Subject: Amendment No. 10 to Facility Operating License No. NPF-13 -
Grand Gulf Nuclear Station, Unit 1

MISSISSIPPI POWER AND LIGHT COMPANY
MIDDLE SOUTH ENERGY, INC.
SOUTH MISSISSIPPI ELECTRIC POWER ASSOCIATION
DOCKET NO. 50-416
GRAND GULF NUCLEAR STATION, UNIT 1
AMENDMENT TO FACILITY OPERATING LICENSE

License No. NPF-13
Amendment No. 10

SAFETY EVALUATION
AMENDMENT NO. 10 TO NPF-13
GRAND GULF NUCLEAR STATION, UNIT 1
DOCKET NO. 50-416

Bases Figure B 3/4 3-1
REACTOR VESSEL WATER LEVEL

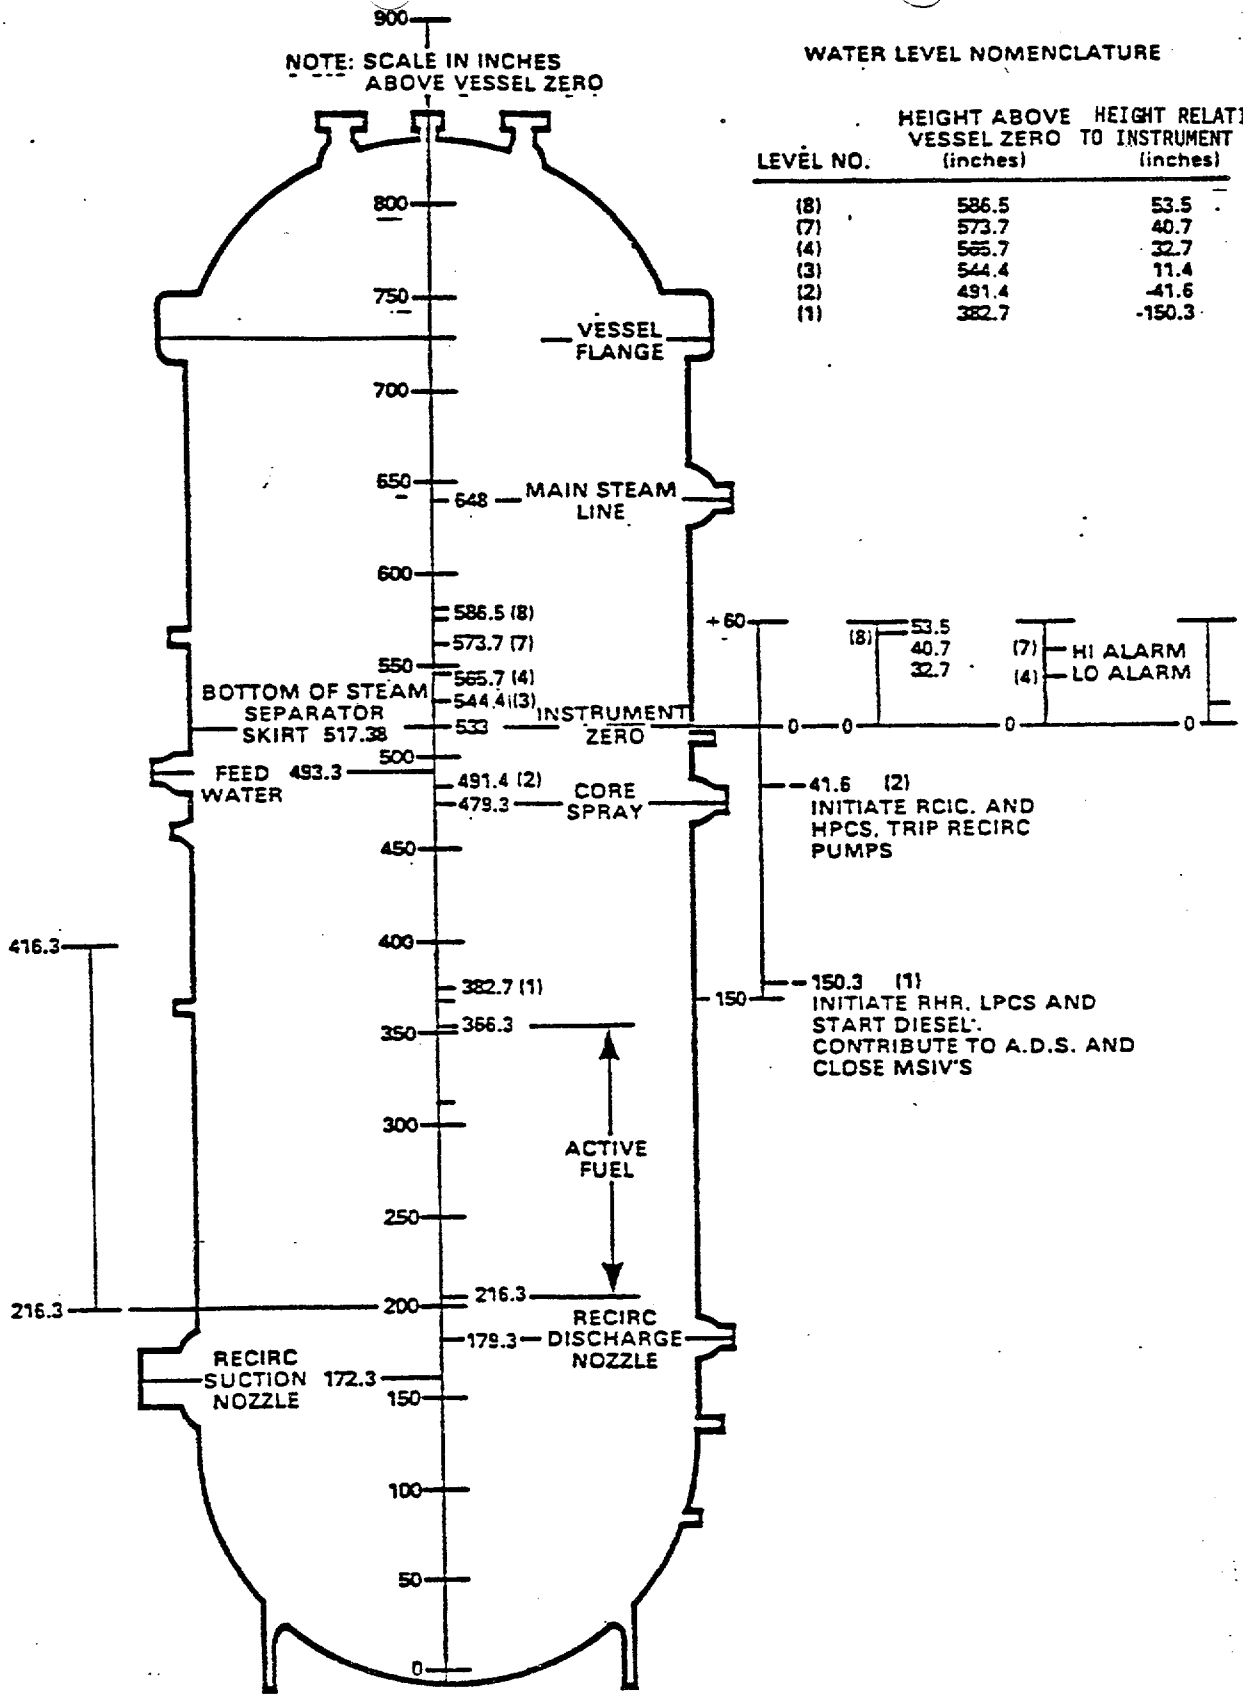
1. Tables 3.3.3-1 and 4.3.3.1-1, Bases Figure 3/4 3-1:
HPCS OPERABILITY

In a letter dated August 1, 1983, MP&L requested changes to the Technical Specifications to modify the Specifications on the high pressure core spray (HPCS) system so that the injection function of Drywell Pressure - High and Manual Initiation are not required to be OPERABLE when the indicated water level on the wide range instrument is greater than Level 8 coincident with the reactor pressure being less than 1025 psig. Informal discussions between the staff and MP&L on August 25, 1983, in regard to the pressure value revised this value to 600 psig. Written confirmation of the 600 psig value was submitted by MP&L in a letter dated September 13, 1983. These changes would be in effect until modifications are made to the instrumentation but no later than startup following the first refueling outage.

The reactor water level instrumentation at Grand Gulf is the condensate chamber reference leg type. These instruments are strictly differential pressure devices which are reactor coolant density sensitive and are calibrated to be most accurate at the specific vessel conditions appropriate for the associated system functions actuated by the instrumentation. The shutdown water level range and fuel zone water level range instruments are calibrated to read accurately at atmospheric pressure; the upset, narrow and wide range water level instruments are calibrated for normal operating conditions (saturated steam at 1025 psig). At low coolant temperatures and pressures, those instruments calibrated for normal operating conditions will read higher than actual level. For example, with an actual level of 21.5" above instrument zero at 120°F and atmospheric pressure, MP&L has observed that the narrow range instrumentation would indicate a level of 32" and the wide range instruments would attempt to indicate a level of 82.5" (in actuality the upper limit of the range of the instrument is 60").

The HPCS discharge valve is interlocked closed at the vessel Level 8 setpoint (less than or equal to 55.7" above instrument zero or 220" above the active fuel). An artificially high level indication at low pressure may result in HPCS isolation when the actual vessel level is below the Level 8 setpoint. The isolation logic may be manually reset once the indicated vessel level drops below this setpoint or it will reset automatically when the indicated vessel level reaches the Level 2 HPCS initiation setpoint (a level of - 41.6" below instrument zero or 125" above the fuel).

Prior to STARTUP following the first refueling outage, the injection function of Drywell Pressure - High and Manual Initiation are not required to be OPERABLE with indicated reactor vessel water level on the wide range instrument greater than Level 8 setpoint coincident with the reactor pressure less than 600 psig.

- # Not required to be OPERABLE when reactor steam dome pressure is less than or equal to 135 psig.
- ## Prior to STARTUP following the first refueling outage, the injection function of Drywell Pressure - High and Manual Initiation are not required to be OPERABLE with indicated reactor vessel water level on the wide range instrument greater than Level 8 setpoint coincident with the reactor pressure less than 600 psig.
